Deepwater Horizon Follow Up Rig Audit, Marine Assurance Audit and Out of Service Period September 2009

Executive Summary

Rig Name:	Deepwater Horizon
Date:	September 2009
ARAS Reference:	1.1.5

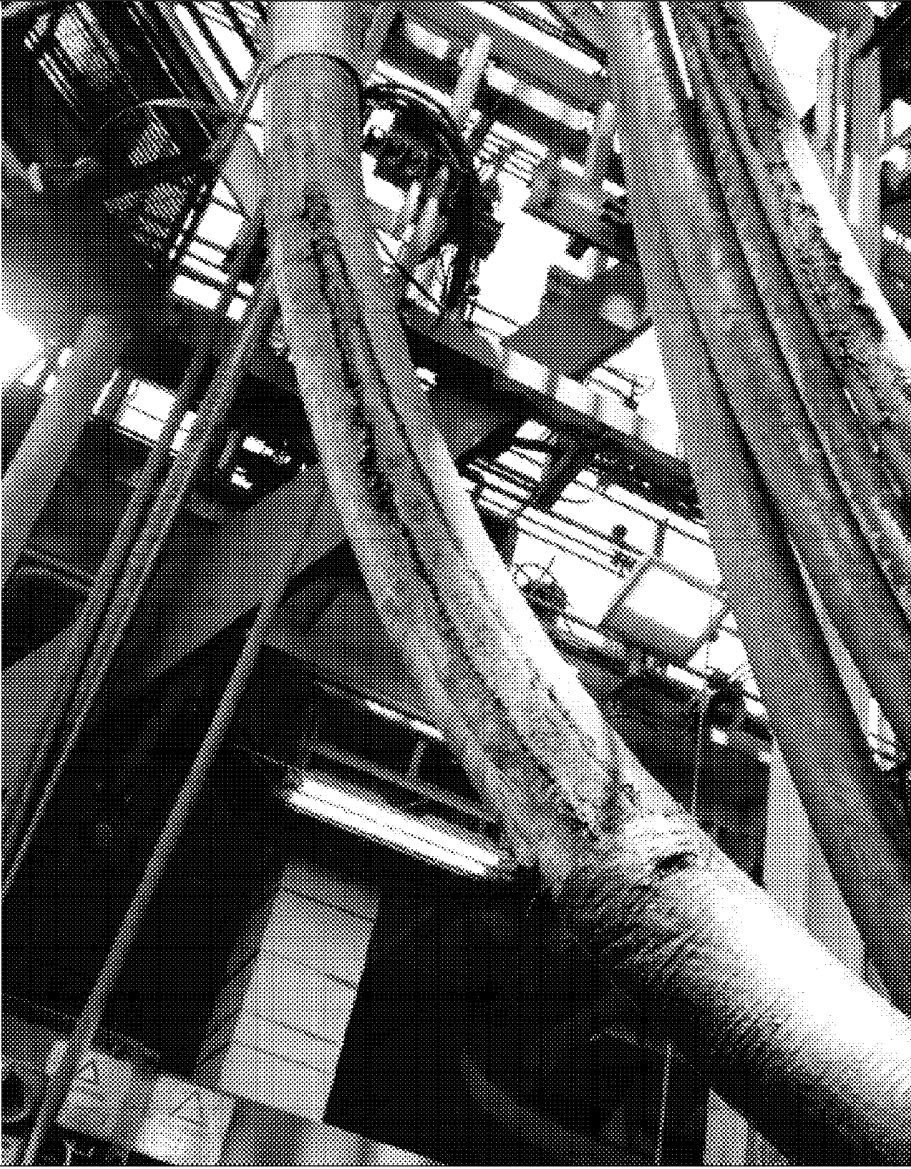
Observations or Comments: <p>Maintenance on watermaker #5, note the front of the unit is opened up but none of the jacket water or seawater valves have been locked or tagged shut.</p>
